**Land off Halifax Road, Thurgoland - Proposed Residential Development of 25 dwellings**
**Planning Application Reference 2018/0028 (Our Ref: 17121)**

# Halifax Road, Thurgoland
# Proposed Residential Development
# Designers Response to Stage 1 Road Safety Audit

# HALIFAX ROAD, THURGOLAND - PROPOSED DEVELOPMENT ACCESS

# Appendix B:  Key Plan

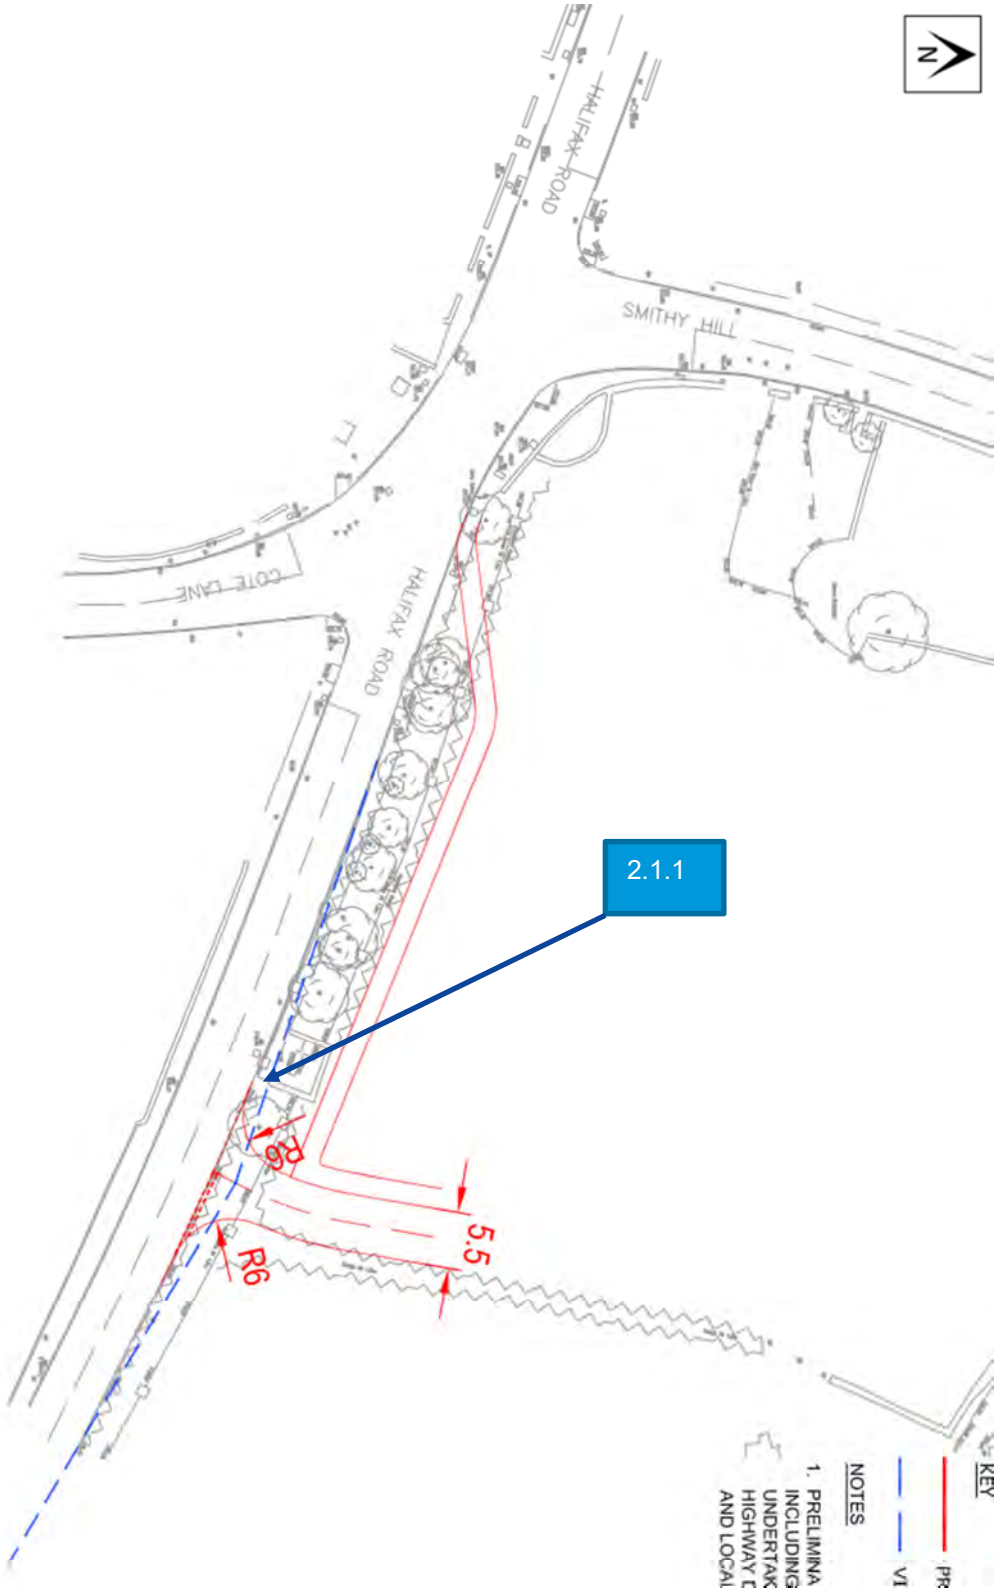
### 2.1.1 Problem

**LOCATION:** Proposed Junction – Halifax Road.

**SUMMARY:** Restricted visibility may lead to 'failure to give-way' type collisions.

Visibility may be restricted by the existing pedestrian guardrail, which could lead to 'failure to give-way' collisions. The existing alignment of the road, and type/length of existing pedestrian guard rail and depending on the development road vertical alignment may restrict visibility.

In addition, the existing vegetation and ivory on the dry-stone wall surrounding the 'water pump' monument, may further impede visibility.

It is recommended to review the existing pedestrian guardrail, with a view to changing the type to be suitable for the road alignment curvature and/or reduce the length of guardrail (retain final three panels) and remove the end panel.

Remove vegetation/ivory between proposed junction and 'water pump' and from the dry-stone wall.

**Designers Response: The audit recommendation is agreed and the appropriate guard railing will be specified and agreed through the Section 38 agreement**

DRAWING TITLE: PROPOSED SITE ACCESS ARRANGEMENTS

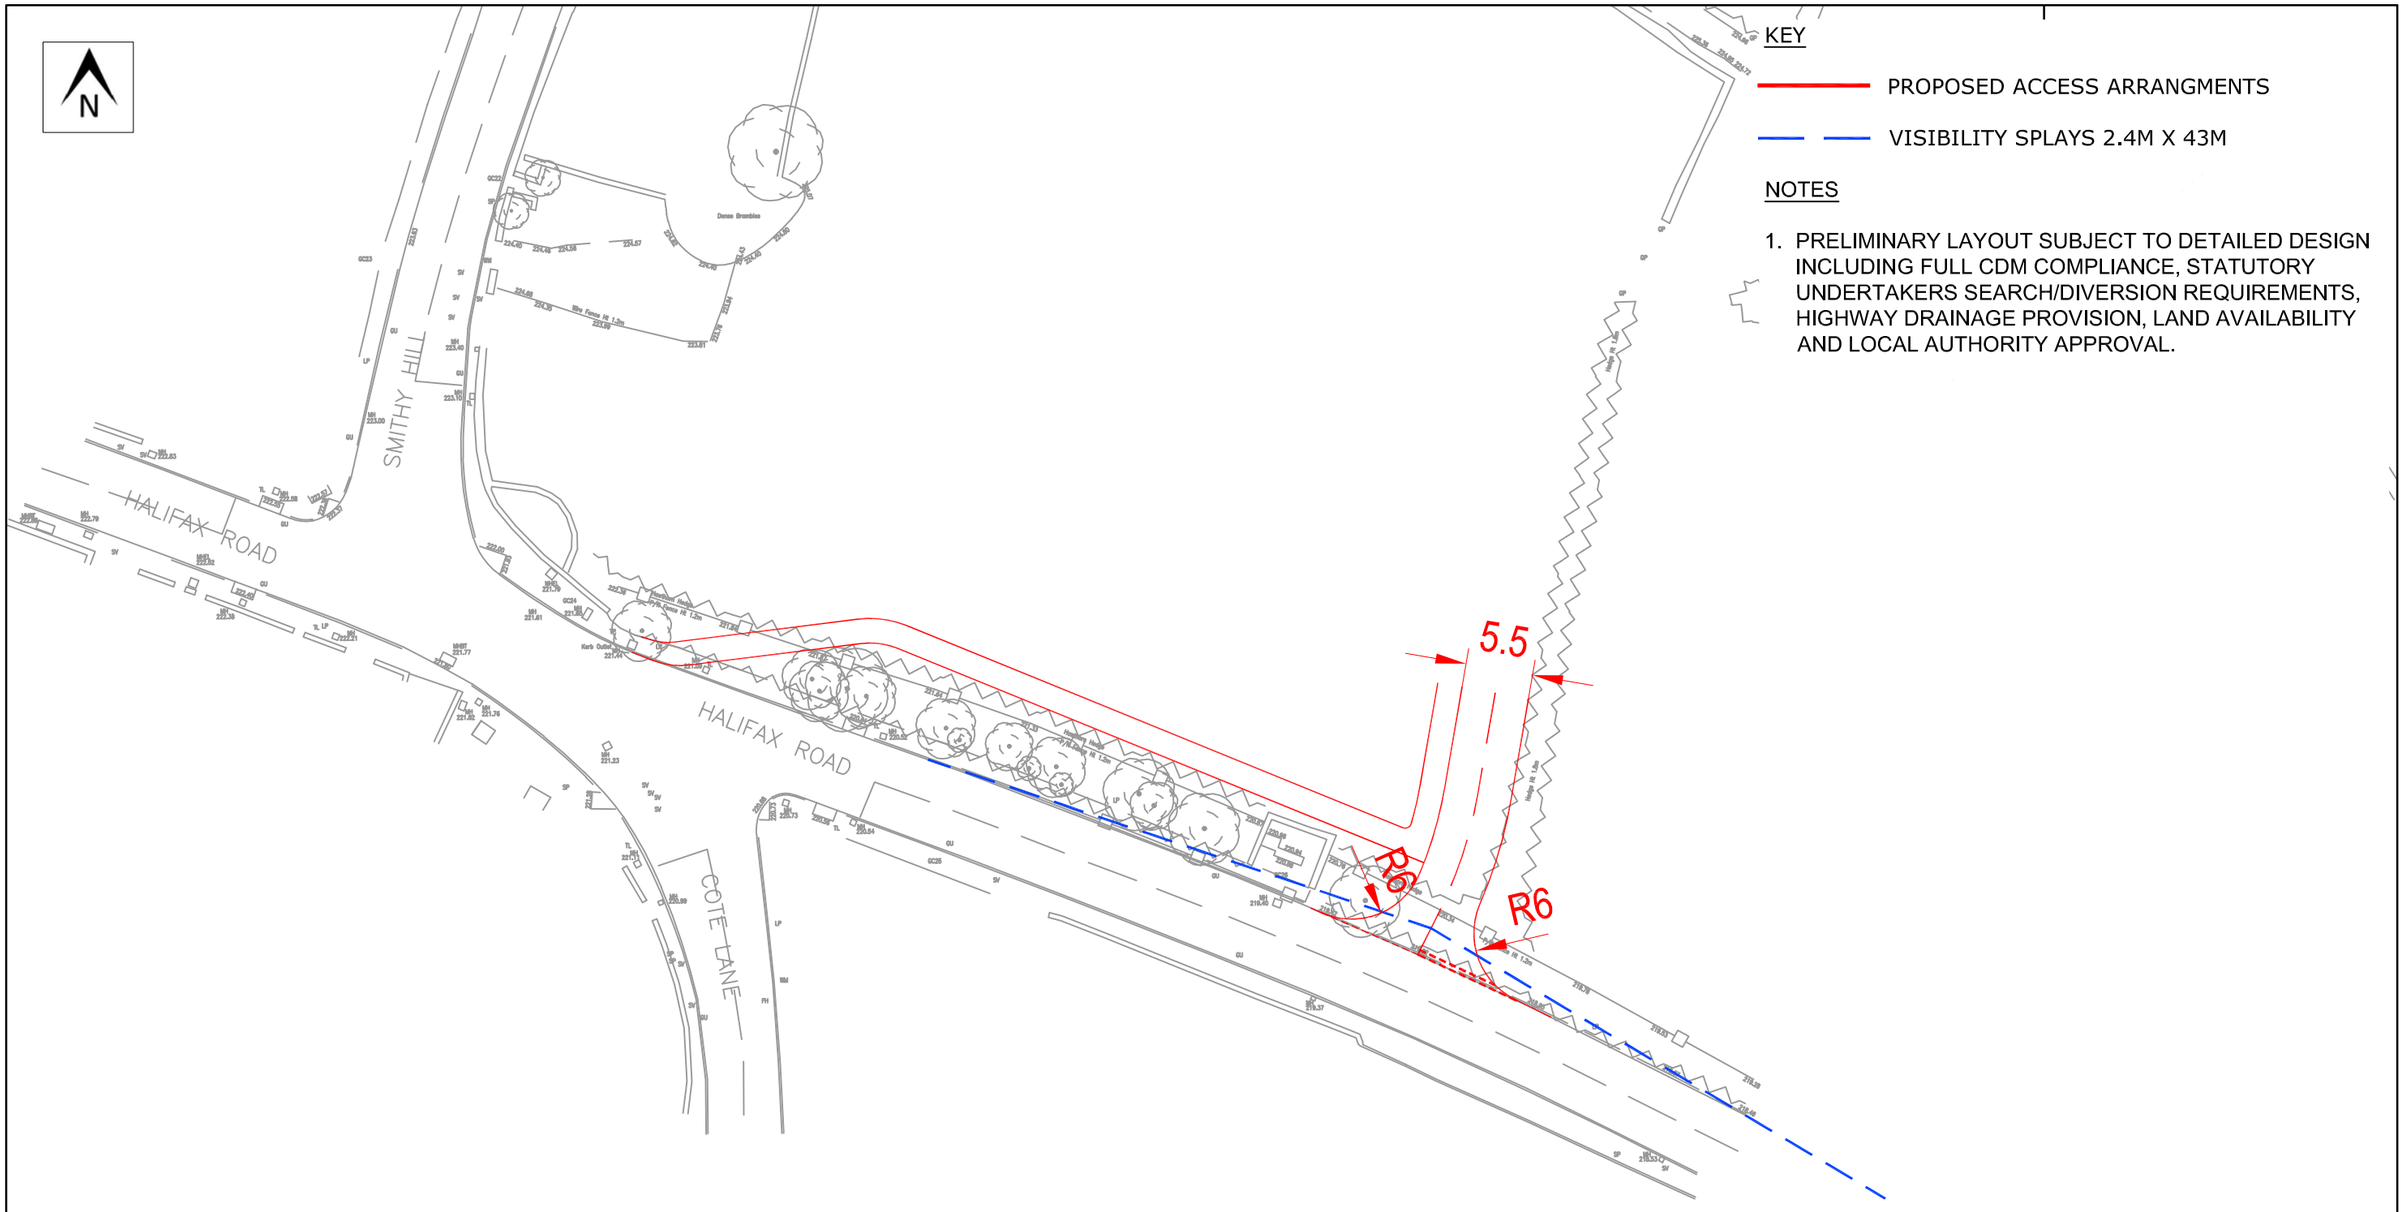
3. ***The carriageway adjacent to the site entrance is of limited width and a right turn lane cannot be accommodated. This will lead to potential delays to through traffic as vehicles wait to turn right into the site. This is also likely to lead to an increase in rear end shunts.***

4. ***There are no pedestrian crossing facilities provided in the signal controlled junction.***

With regard to highway safety, drawing 17121/GA/01 A confirms that appropriate visibility splays can be achieved from the proposed access point and northbound traffic has substantial forward visibility to view both an emerging vehicle and a vehicle slowing to turn right into the site.

Pedestrian crossing facilities are provided at the signal controlled junction. Dropped kerbs with tactile paving are provided across all arms of the junction. These are identified on the topographical survey on drawing 17121/GA/01.

DRAWING TITLE: SWEPT PATH ANALYSIS

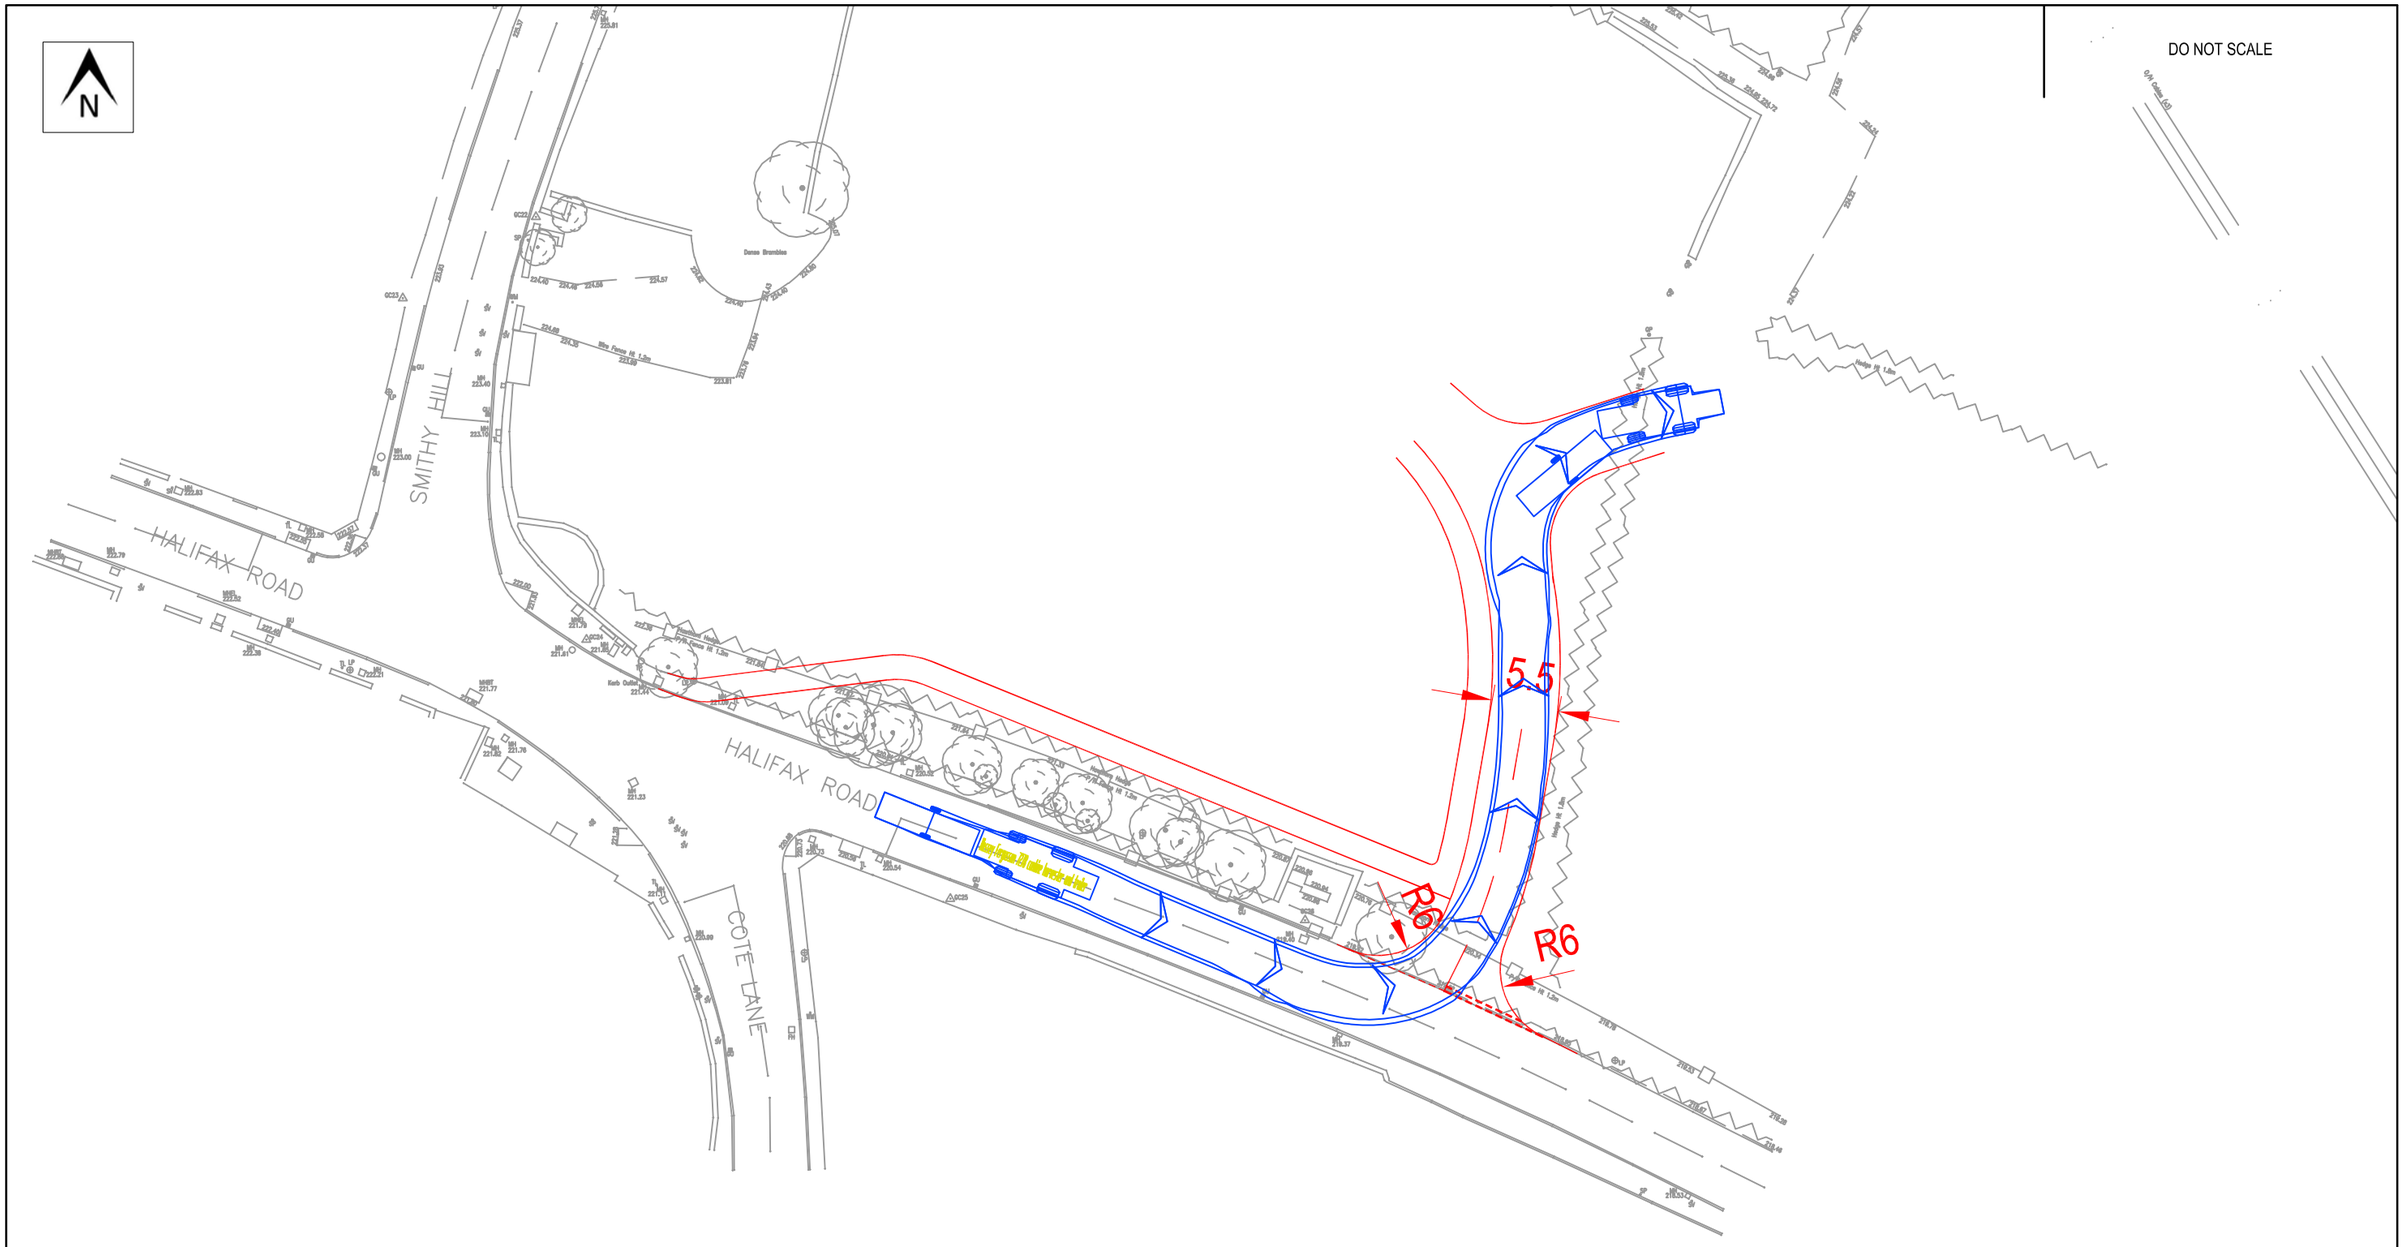
5. ***The proposed access road also gives access to an adjacent field. Details regarding the largest size, type and frequency of vehicle expected to use this access should be submitted to assess whether it appropriate to use a residential road. The radii, carriageway width and construction may have to be adjusted accordingly.***

Drawing 17121/ATR/01 has been produced in order to demonstrate that the largest vehicle that requires access to the development can be accommodated.
